DOCKETED	
Docket Number:	24-OPT-01
Project Title:	Perkins Renewable Energy Project
TN #:	257953
Document Title:	Perkins CEC Data Request Response Set #1 for the Opt-in Application 24-OPT-01 Part 1
Description:	Response Set #1 for the CEC Data Request for the Perkins Renewable Energy Project Opt-in Application 24-OPT-01
Filer:	Emily Capello
Organization:	Panorama Environmental, Inc.
Submitter Role:	Applicant Consultant
Submission Date:	7/23/2024 11:31:00 AM
Docketed Date:	7/23/2024

**California Energy Commission
Perkins Renewable Energy Project
CEC Data Request Response Set #1 for the
Opt-in Application 24-OPT-01**

CEC Data Request Response Set #1 for the Opt-in Application 24-OPT-01

Figure 1 Sensitive Receptors in Proximity to the Project

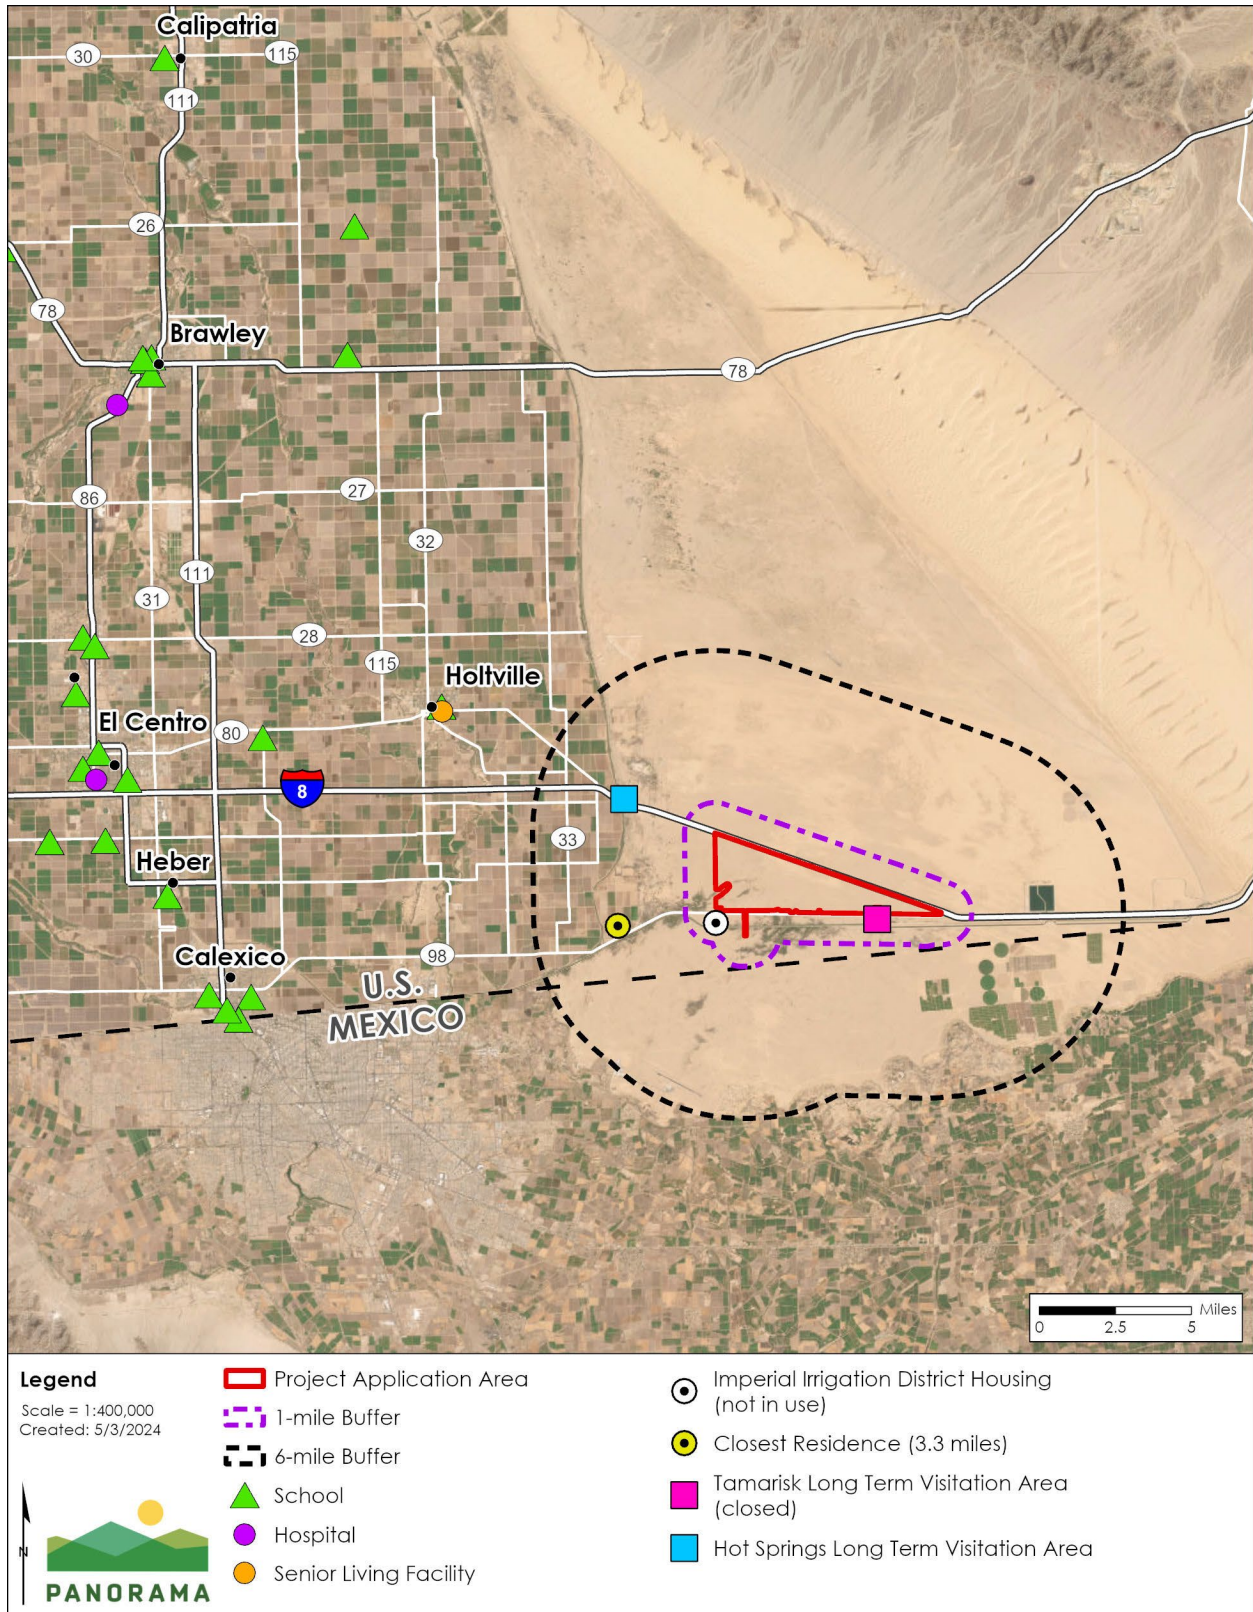
DR AQ-6: Please provide the meteorological data that includes quarterly wind tables and wind roses, ambient temperatures, relative humidity, stability and mixing heights, upper atmospheric air data, and an analysis of whether this data is representative of conditions at the project site.

Response: The nearest sensitive receptor that could be exposed to criteria air pollutants generated by the Project is a residence located approximately 3.3 miles to the west of the Project as shown in Figure 1, below. As indicated in the Application, the Tamarisk Long Term Visitation Area (LTVA) has been closed by the Bureau of Land Management (BLM), and the former Imperial Irrigation District (IID) worker housing near the Project is no longer in use and does not house any sensitive receptors. The Hot Springs Long Term visitation area is an estimated 3.3 miles west of the project site. Due to the absence of sensitive receptors within 3

miles of the project, screening level modeling analysis of criteria air pollutants generated during Project construction and operation was conducted using the U.S. EPA's AERSCREEN dispersion model (Attachment A.2; Attachment A to this Response Set #1). Because AERSCREEN applies a theoretical worst-case scenario for meteorological conditions (i.e., wind speed, wind direction, temperature, and atmospheric stability) to conservatively estimate pollutant concentrations, the use and analysis of local meteorological data was not required.
